Radiological Assessment for Cabot Corporation Revere, PA Site

Technical Evaluation Report

**Prepared by: Mark Thaggard, Sr. Systems Performance Analyst
Environmental and Performance Assessment Branch**

Figure 1. Generalized conceptual model used in the Cabot-Revere assessment.

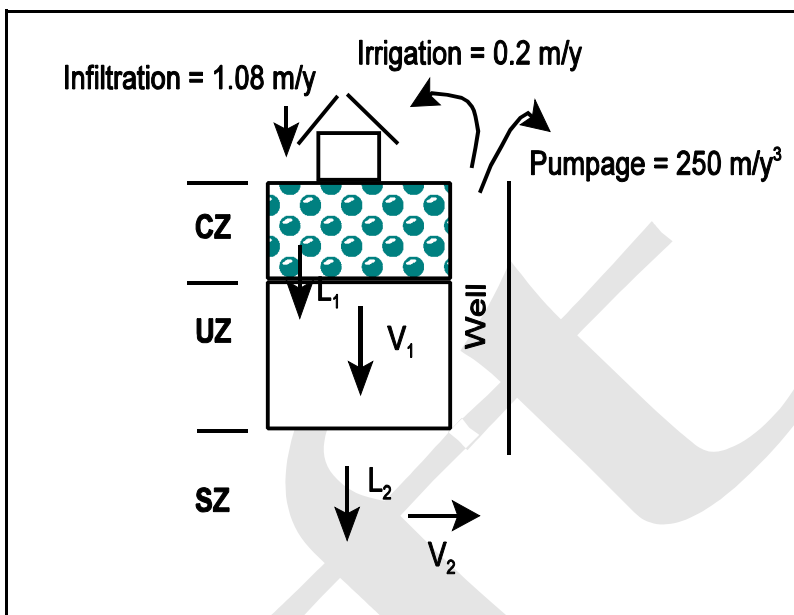
Figure 1 shows a schematic of the general conceptual model used in the Cabot-Revere radiological assessment, based upon staff's interpretation of the information presented in the report.

It should be noted that a default irrigation rate of 0.2 m/y was used in the analysis although the licensee assumed no irrigation as part of either scenario. However, the 0.2 m/y irrigation rate assumed in the analysis only has the effect of slightly increasing the calculated infiltration rate, which slightly increases the calculated leach rate.

Based on regional information, the unsaturated zone is believed to be roughly 20 m thick; however, for the assessment nominal credit is taken for the possible hold-up of contaminants

migrating through the unsaturated zone. This is reflected by the small unsaturated zone thickness (0.01 m) assumed for the analysis and the fact that the K_d for the unsaturated and saturated zones were set to zero. Staff believes that this adds conservatism to the calculated doses for the water-dependent pathways.
